## CITY OF MARLBOROUGH MEETING POSTING

Meeting: **Planning Board**  
Date: **December 21, 2020**  
Time: **7:00 PM**  
Location: **REMOTE MEETING NOTICE**

Subject: Four-Lot Subdivision, 76 Broad Street, Marlborough, MA  
**Response to Engineering Division review comments**

DEFINITIVE SUBDIVISION PLAN

## DETAILS SHEET 2

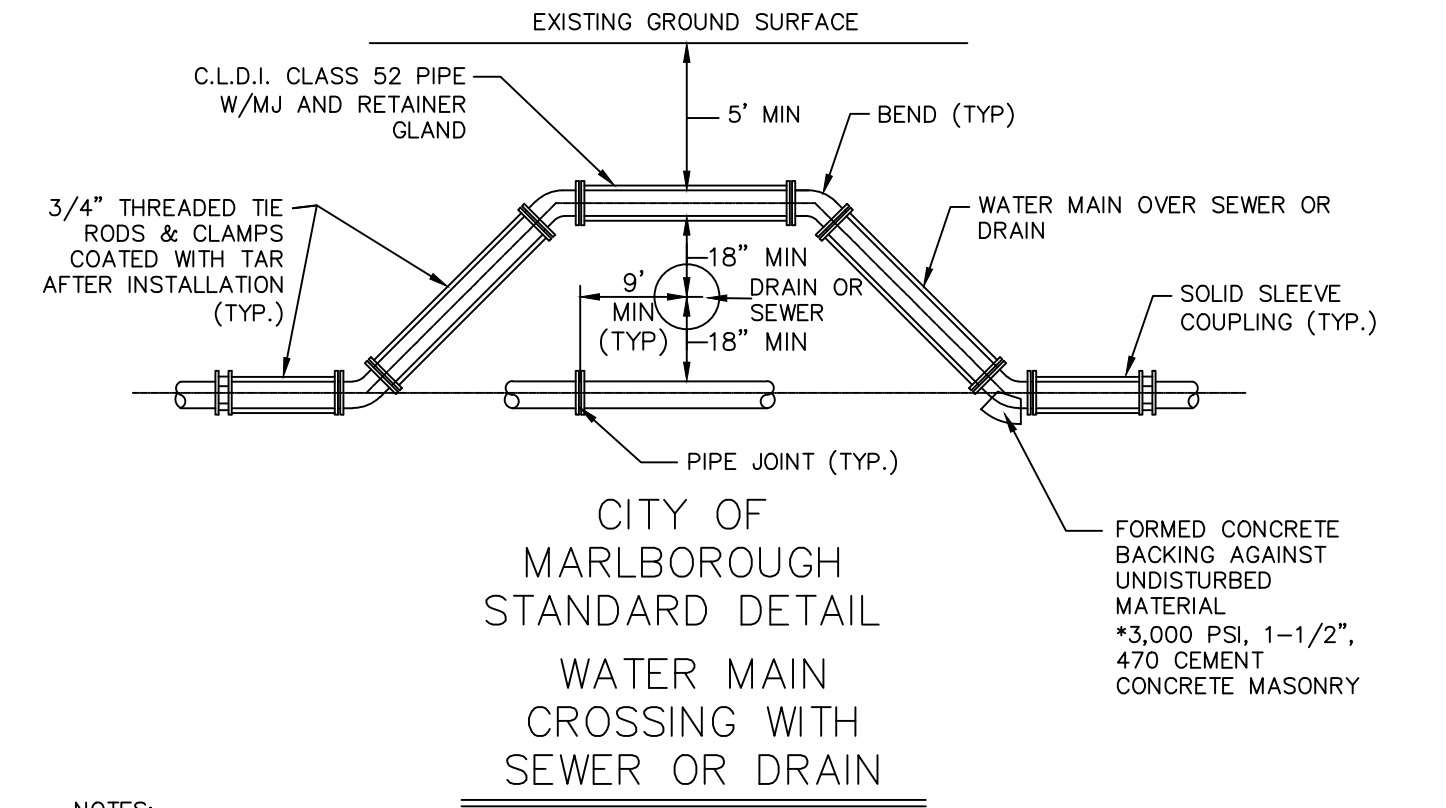
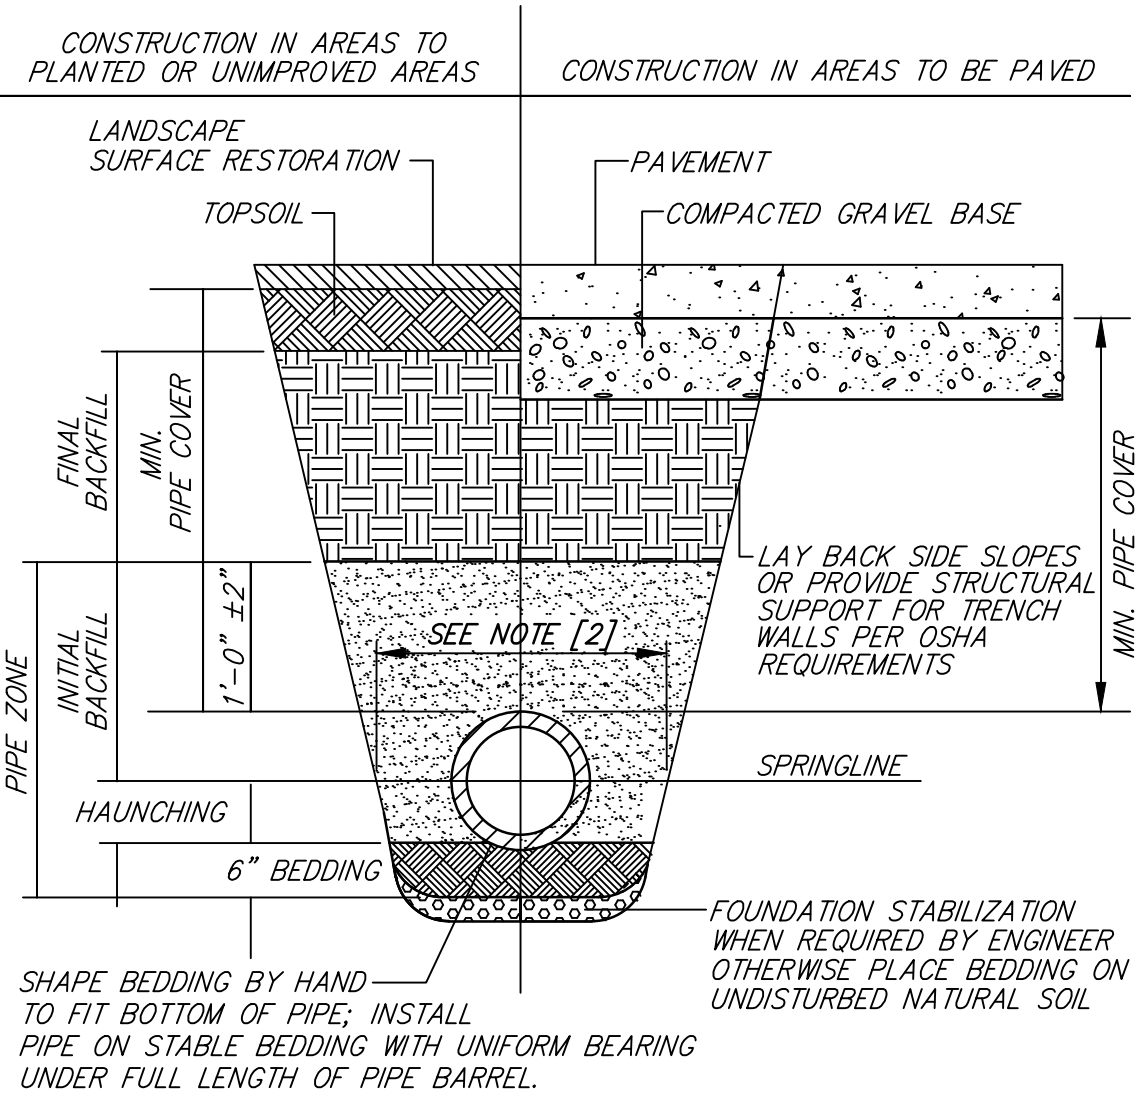
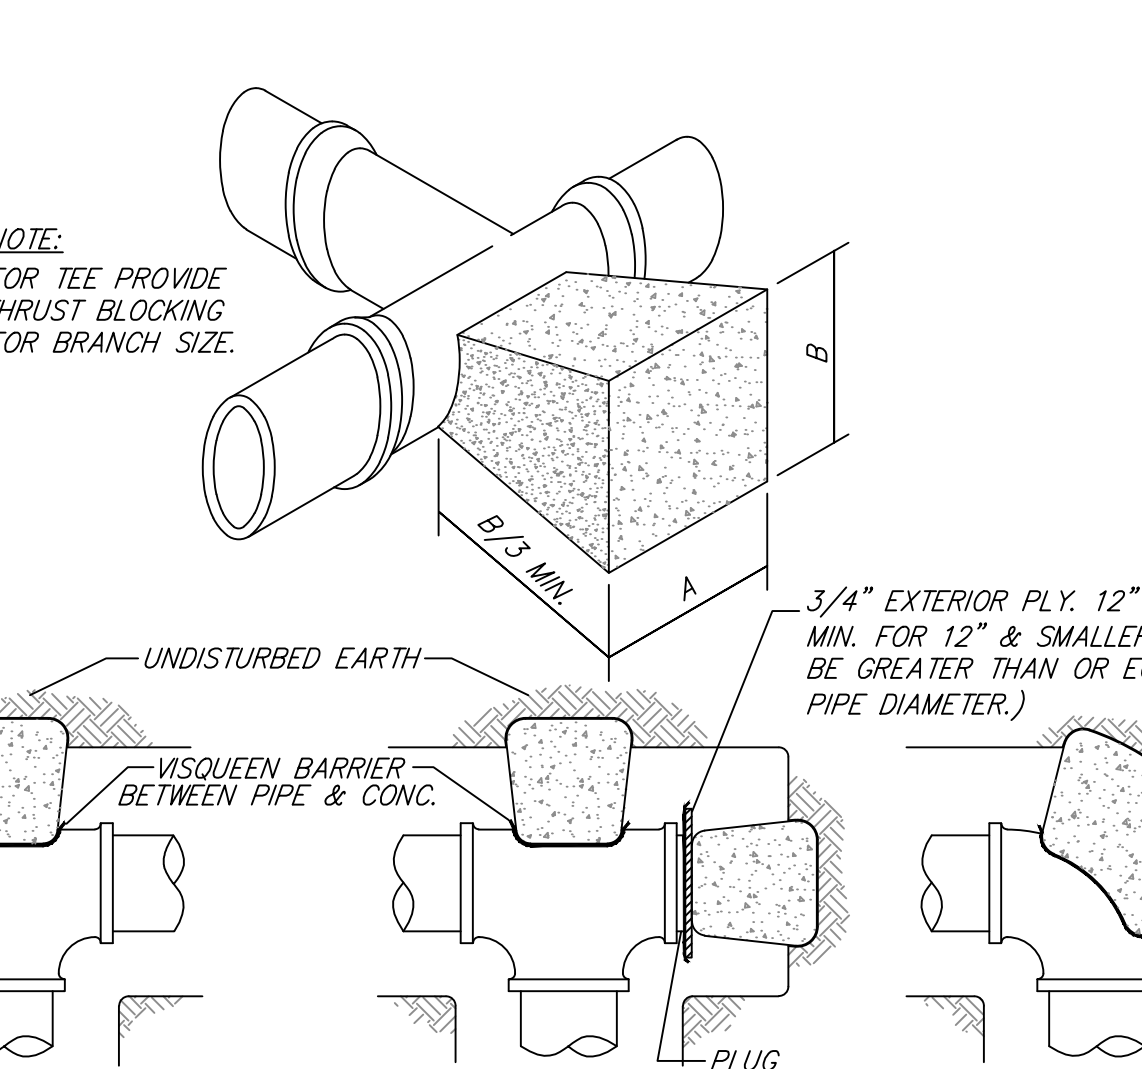
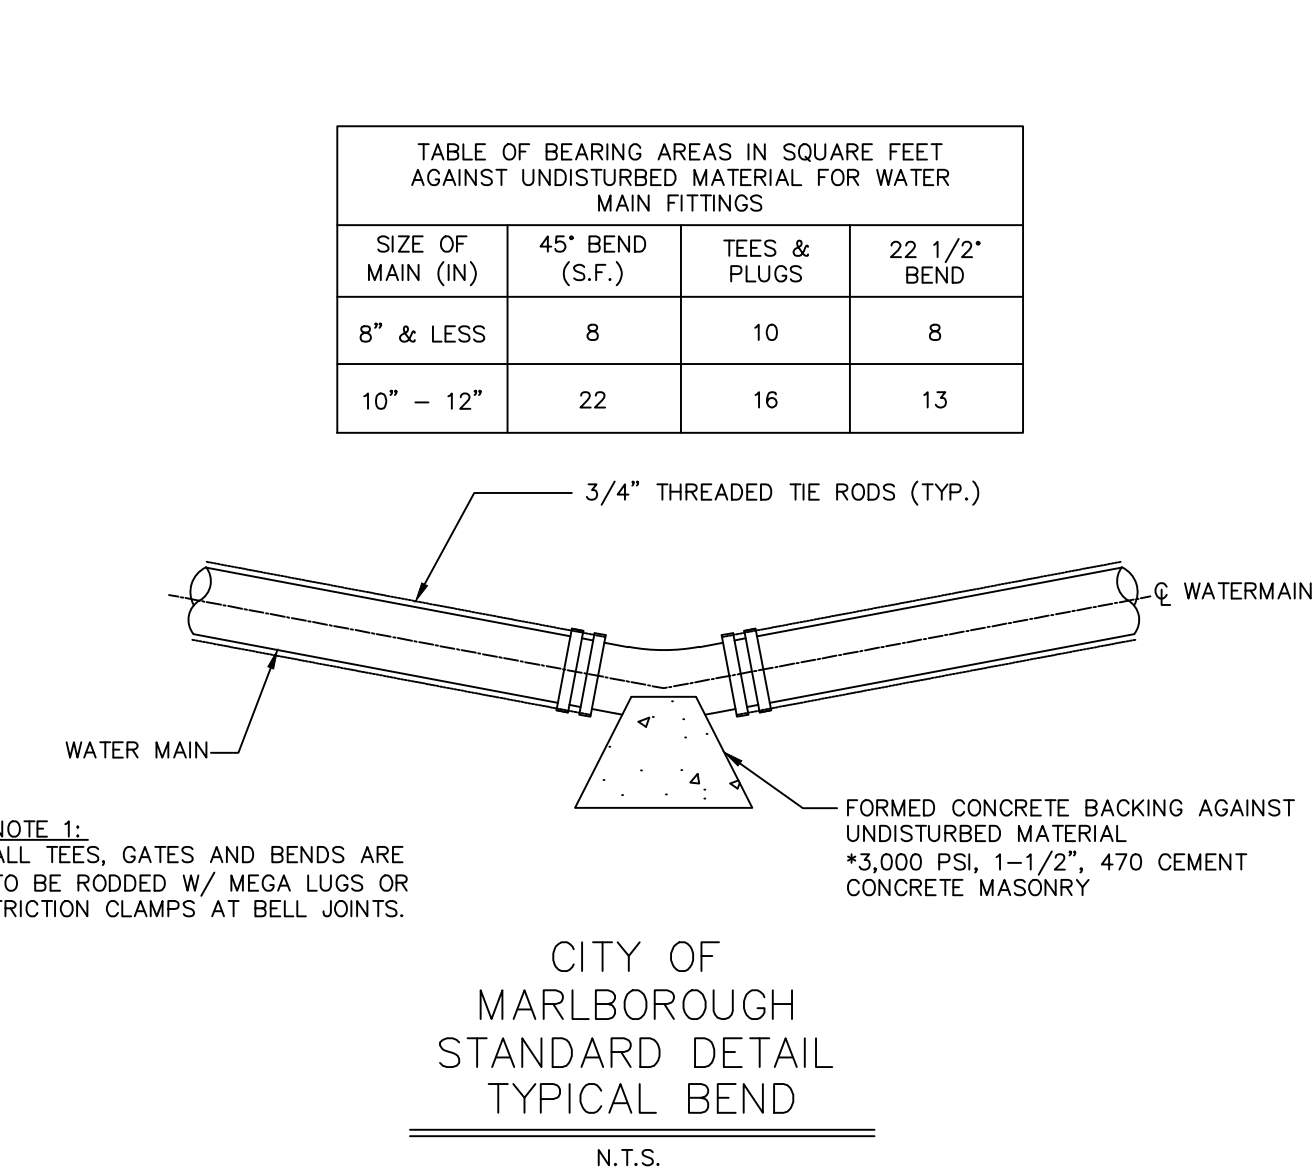
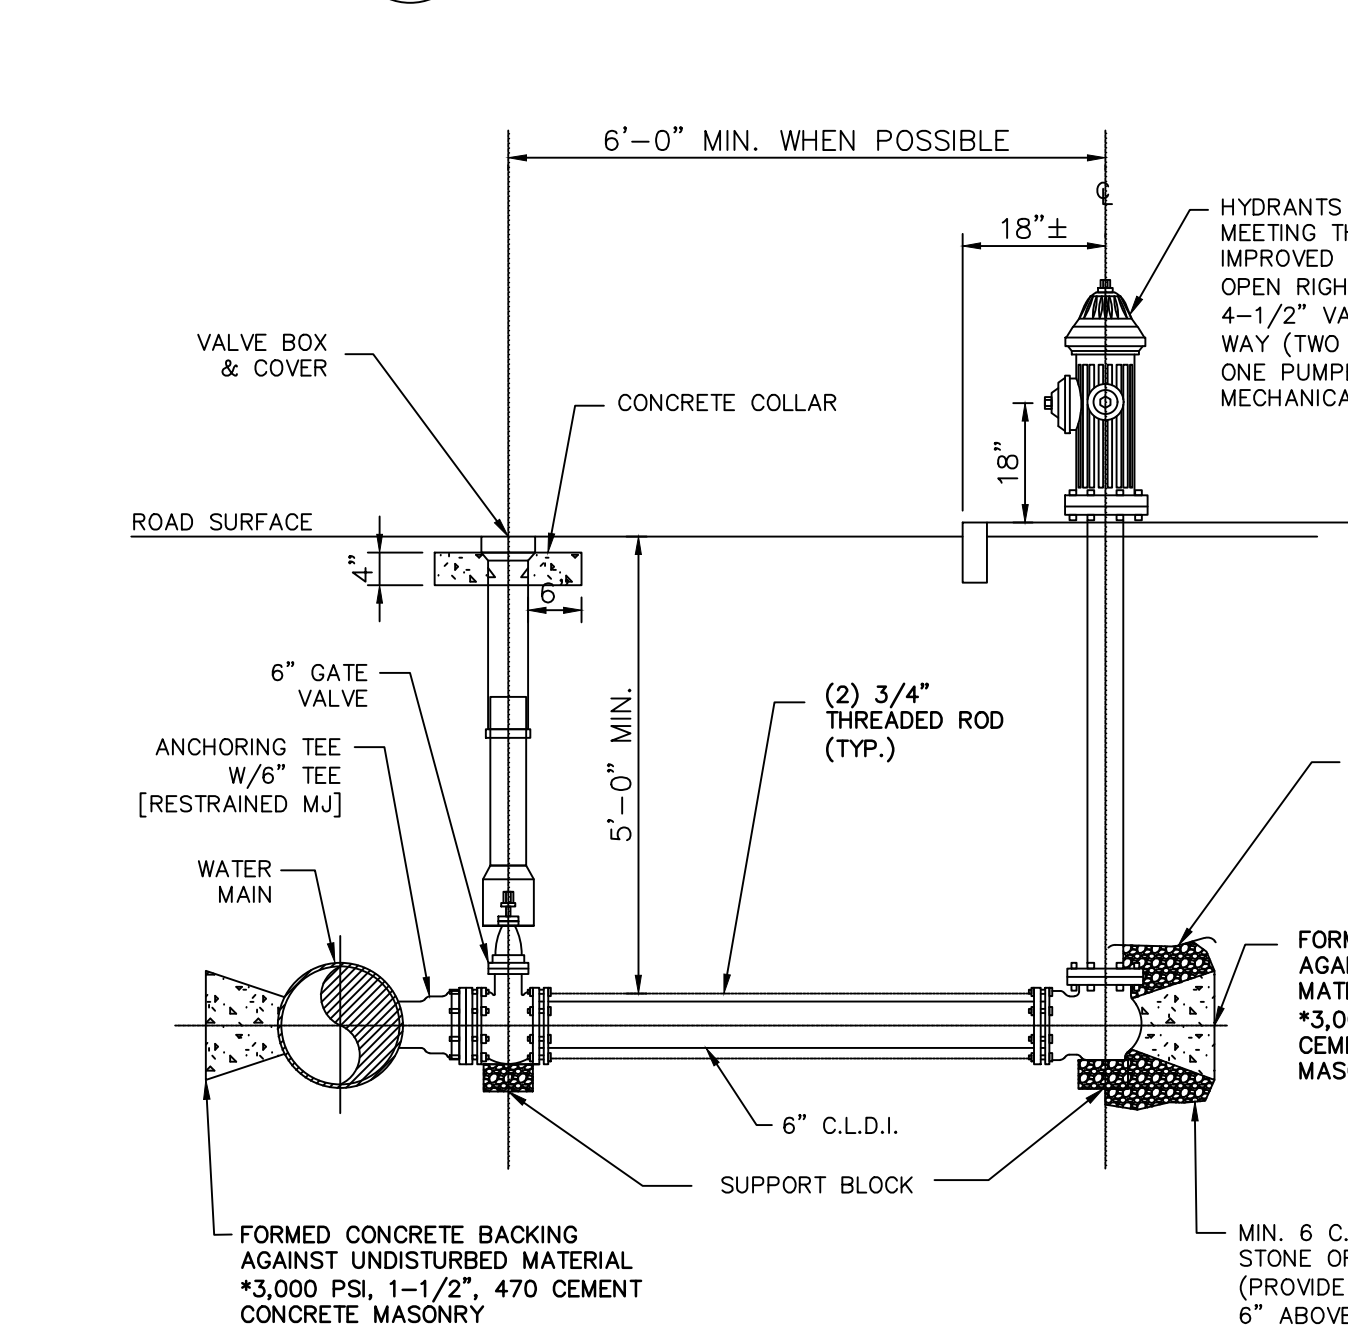
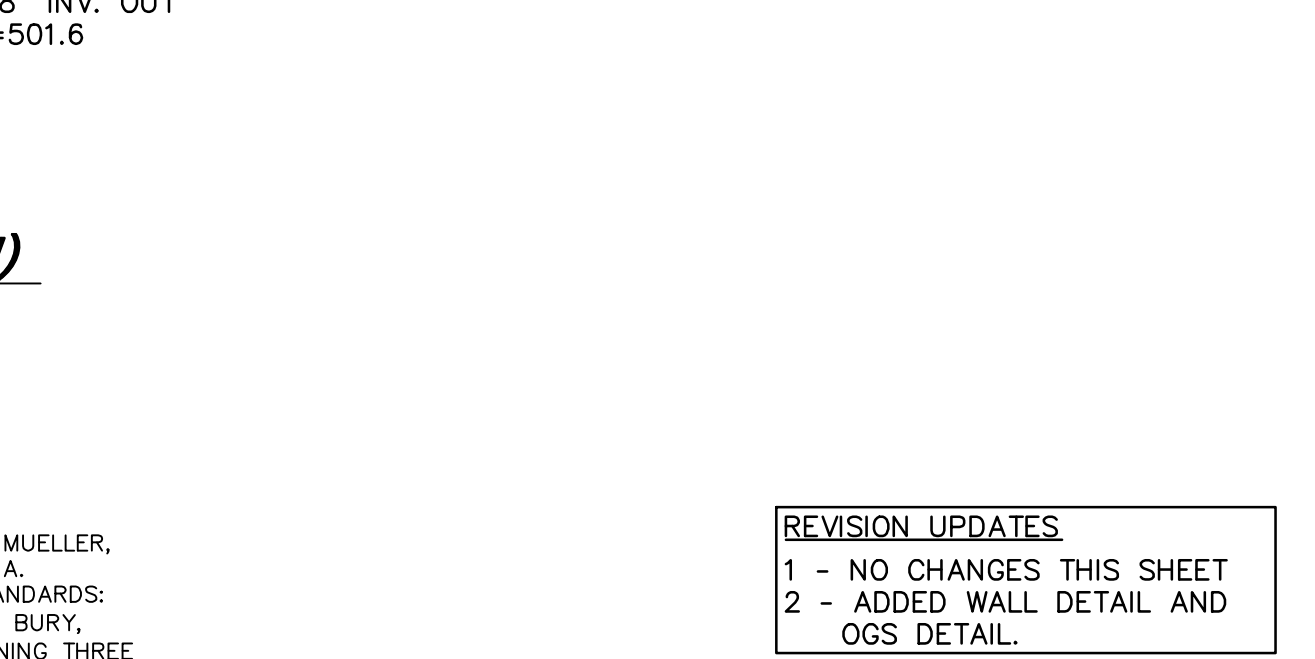
- A detail should be provided for the proposed retaining wall. The interlocking precast concrete blocks used for the wall shall be at least 2,000 lbs. each.

- A detail should be provided for the proposed "3-chamber oil/grit separator". This structure shall have 24" cast iron covers to grade over each of the chambers.

- A fence shall be constructed along the top of the retaining wall. A detail shall be provided.

**Response: A detail has been added to the Details Sheet 2 (C11).**

**Response: A detail has been added to the Details Sheet 2 (C11). The callout for the oil/grit separator on the Grading and Drainage Plan (C6) has been revised.**

**Response: The Grading and Drainage Plan (C6) has been revised. A detail has been added to the Details Sheet 2 (C11).**

REVISION UPDATES			
1	- NO CHANGES THIS SHEET		
2	- ADDED WALL DETAIL AND OGS DETAIL.
